Dominion Nuclear Connecticut, Inc.
Millstone Power Station
Rope Ferry Road
Waterford, CT 06385

Millstone Nuclear Power Station, Unit Nos. 2 and 3
Technical Specifications Change Requests 2-21-01 and 3-18-01
Relocation of Selected Technical Specifications Related to the Reactor Coolant System
and Plant Systems

Technical Specifications Change Request 2-21-01
Relocation of Selected Technical Specifications
Related to the Reactor Coolant System and Plant Systems
Marked Up Pages

Technical Specifications Change Request 3-18-01
Relocation of Selected Technical Specifications
Related to the Reactor Coolant System and Plant Systems
Marked Up Pages

FIGURE 4.7-1
SAMPLE PLAN 2) FOR SNUBBER FUNCTIONAL TEST

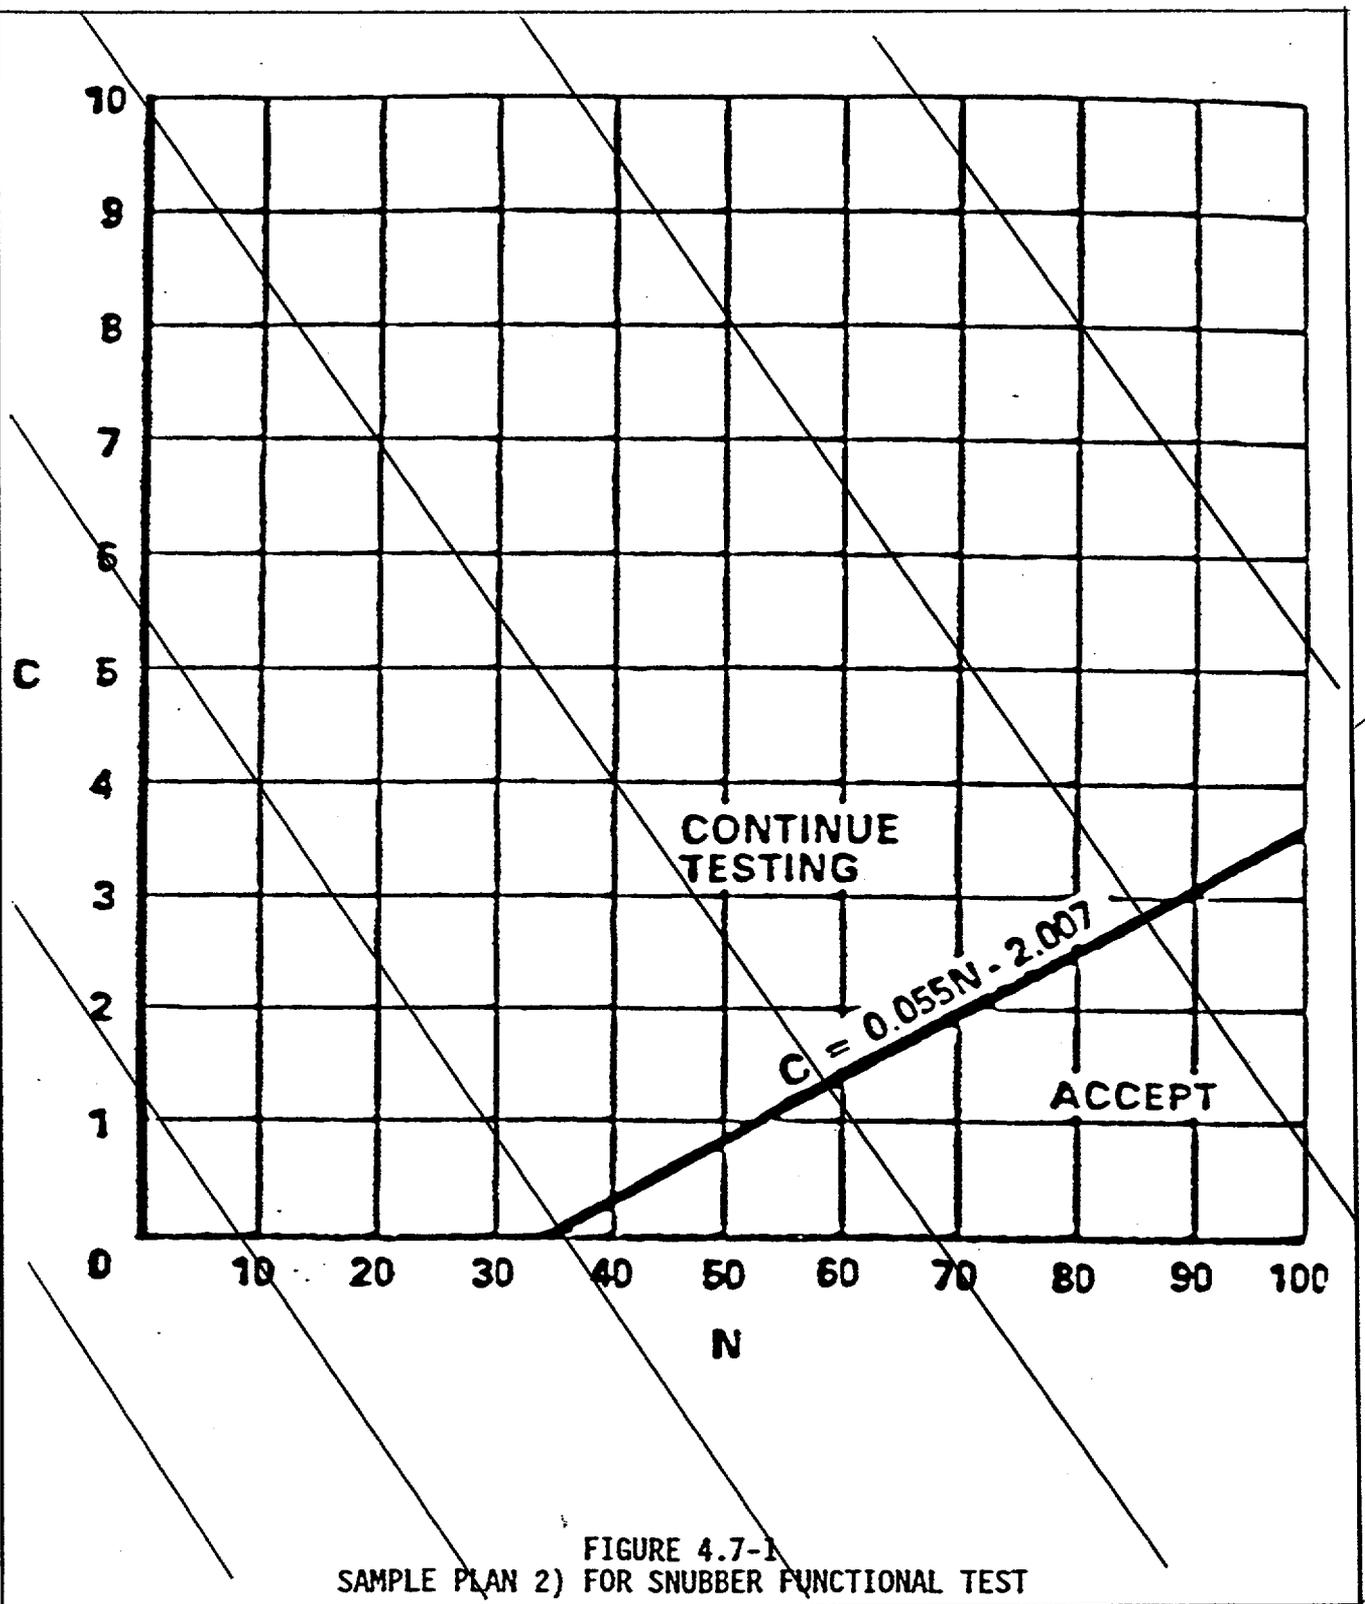
Replace with

↑
THIS PAGE INTENTIONALLY LEFT BLANK
